IREDELL COUNTY HEALTH DEPARTMENT

Statesville Office (704) 878-5305 Mooresville Office (704) 660-3625 PERMIT # 203896

IMPROVEMENT PERMIT / AUTHORIZATION TO CONSTRUCT / OPERATION PERMIT / EXISTING SYSTEM

APPLICANT: Michelle Gioletti APPLICANT ADDRESS: 124 Stover Rd Mooresville NC 28117

INITIAL SITE SKETCH

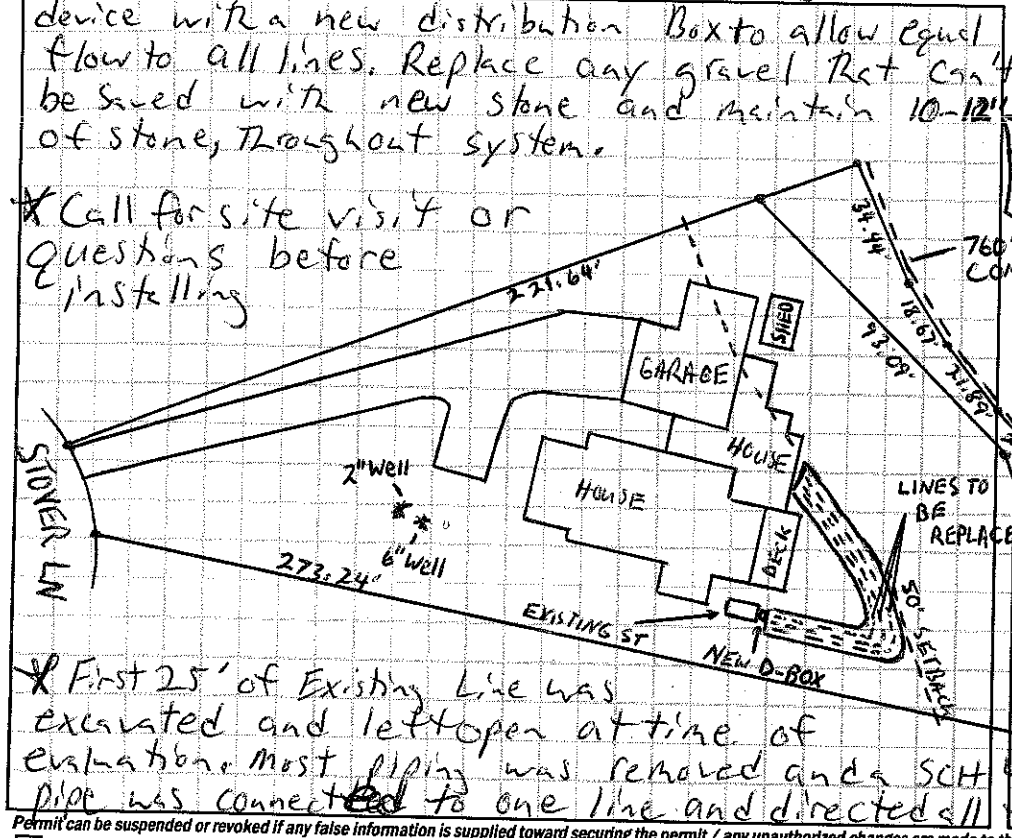
Comments / Conditions: *Replace all clogged lines in existing bed System w/ new corrigated pipe or place new pipe beside existing clogged pipe. If piping is not clogged do not disturb. Replace missing distribution device with a new distribution Box to allow equal flow to all lines. Replace any gravel that can't be saved with new stone and maintain 10-12" of stone, Throughout system.

*First 25' of Existing Line was excavated and left open at time of evaluation. Most piping was removed and a SCH 40 PVC pipe was connected to one line and directed all flow to it from tank.

AS BUILT SKETCH

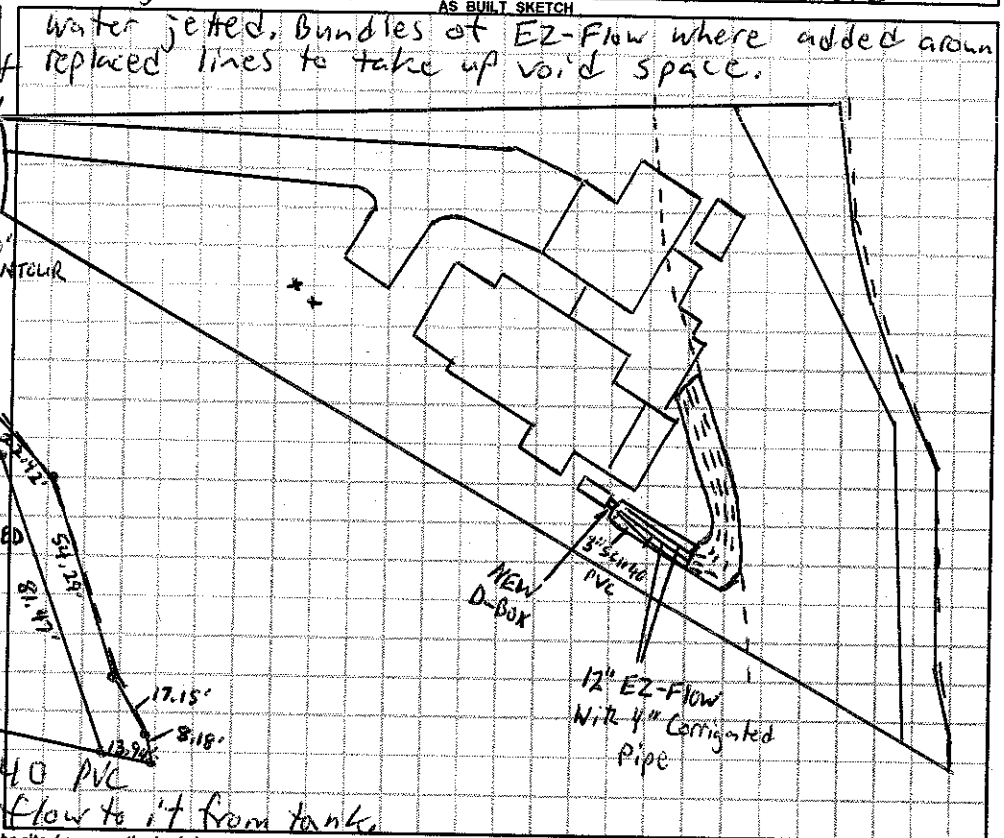
*New D-Box added, Lines closest to deck replaced w/ EZ-Flow from D-Box to ~25' out, Line furthest away ~10' of SCH 40 PVC pipe used to reconnect to existing line. Existing bed was Terra Lifted and lines were water jetted. Bundles of EZ-Flow where added around replaced lines to take up void space.
